Materials Recovery Facility
Safety Observation Form

Date: Thursday, June 23, 2016

Name of Observer: Shawn Qualls

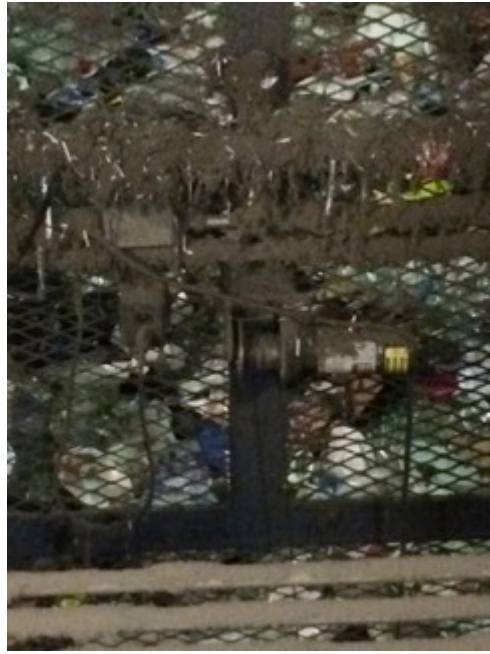
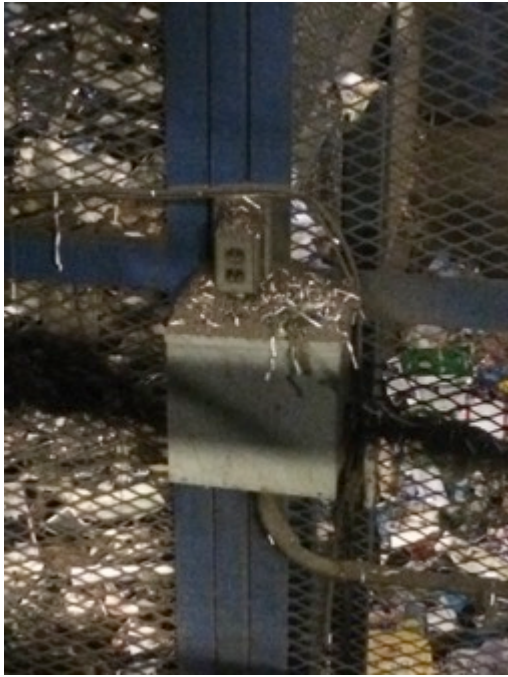
Improper chemical storage:

- Placed in pinch-point between wall and mobile equipment
- No labels

All:

- Dust & debris built up atop electrical equipment – fire hazard
- Cover not secured
- Improper labeling [1910.303(e)]

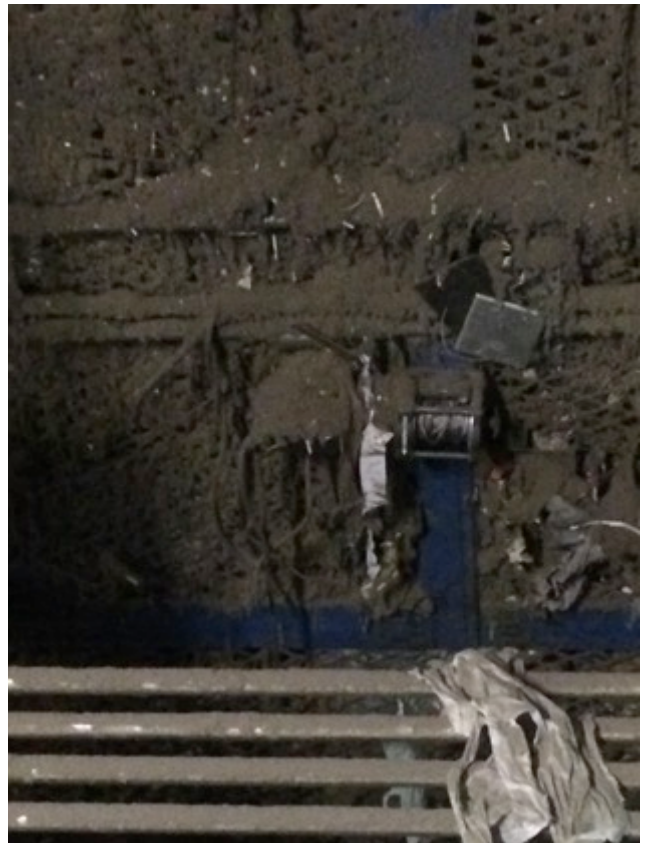
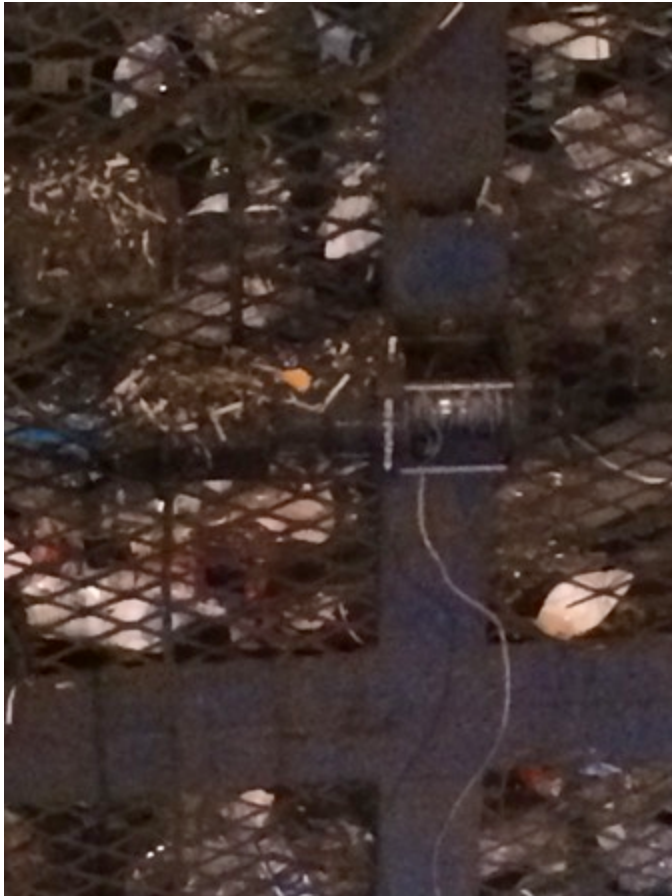
All: Dust & debris atop electrical equipment – fire hazard

All: Dust & debris in/on/around electric motors. Susceptible to overheating/failure; fire hazard

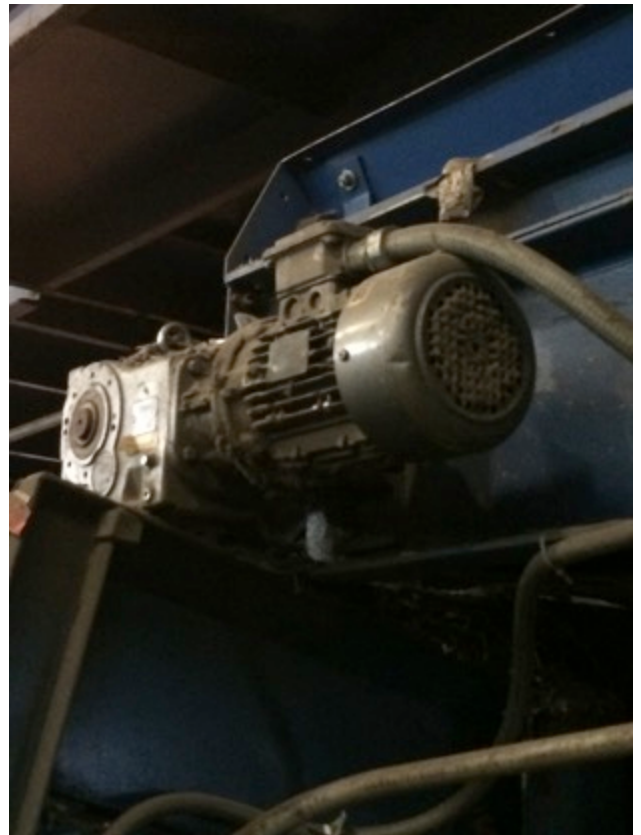
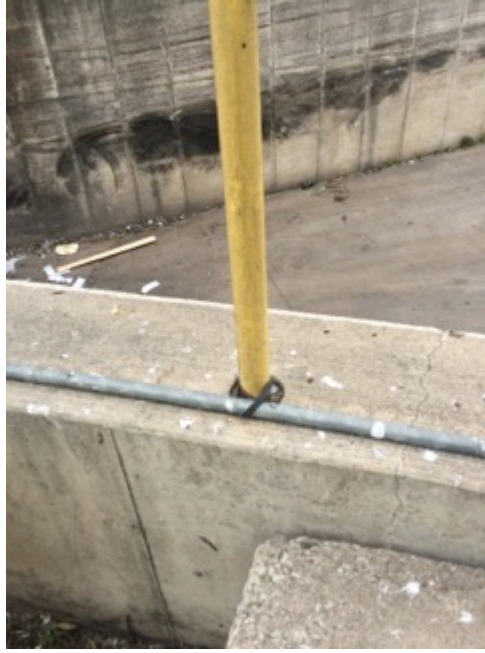
Top left & middle: metal caps not secured, screws missing

Left: GFCI

- Improperly secured to railing
- No cover

Right: Improperly secured

Bottom:

- Broken extension cord w/ exposed leads
- Cord not removed and stored immediately after use
[1910.305(a)(2)(ii)]

All: Improper materials storage/poor housekeeping

Bottom: Container not labeled

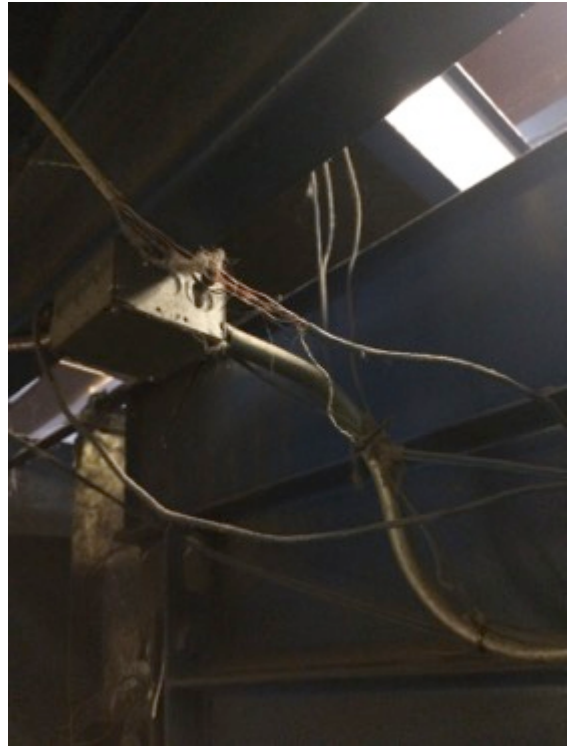
Top:

- Exposed wiring
- Damaged switch
- Cover not secured
- Improper labeling

Bottom:

- Damaged conduit
- Proximity to drainage pipe

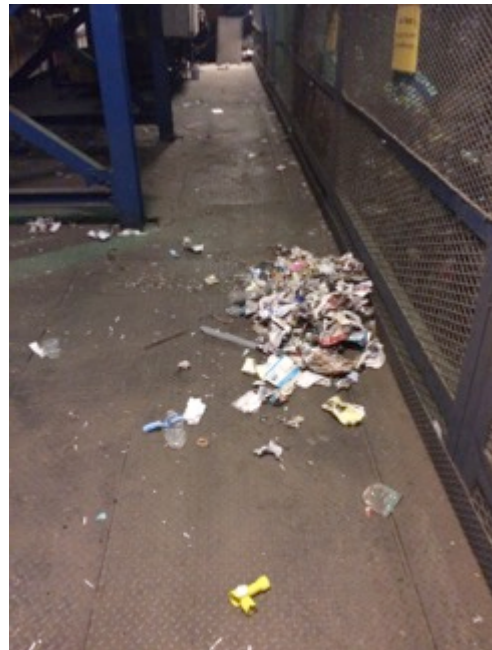
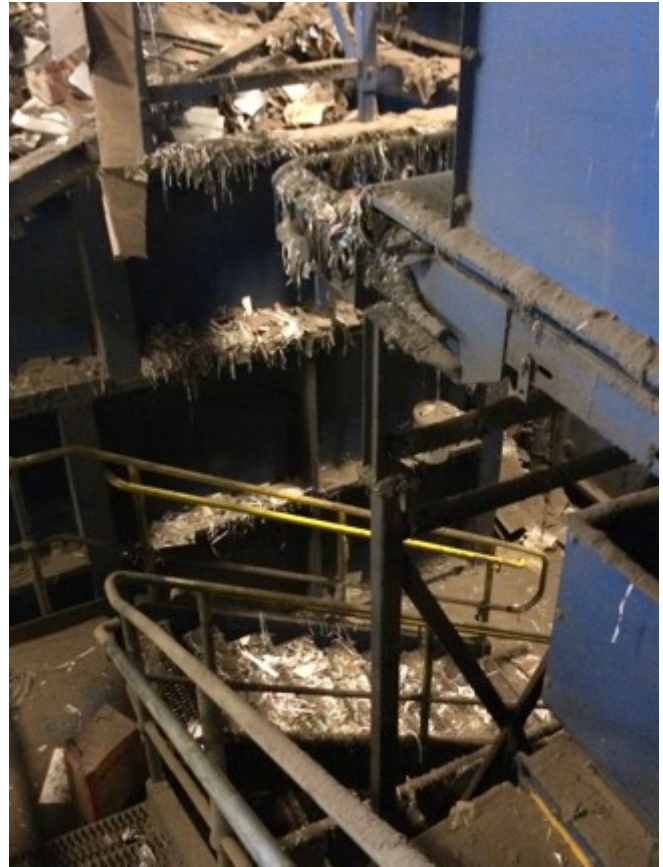
All: Exposed wiring
Bottom right: dust/debris build-up

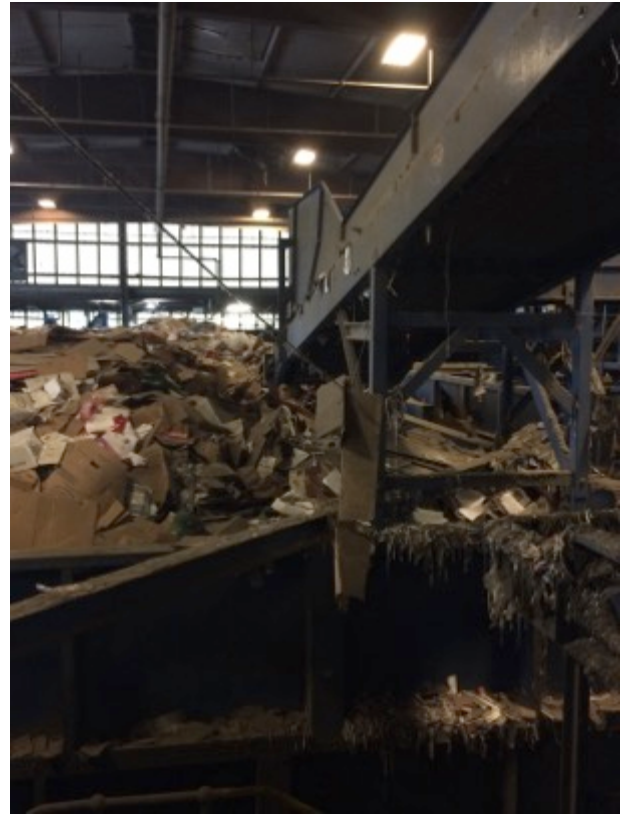
All:

- Walkways/stairways blocked
- Poor housekeeping

Top left: dust/debris built up atop heater – fire hazard

Top right: wiring strung over/underneath machinery, large piece of cardboard got caught on it.

Bottom: moving part left unguarded

Top left: Not properly labeled

Top right: high-voltage line not secured

Bottom: lockers set on uneven surface, potential crush hazard.
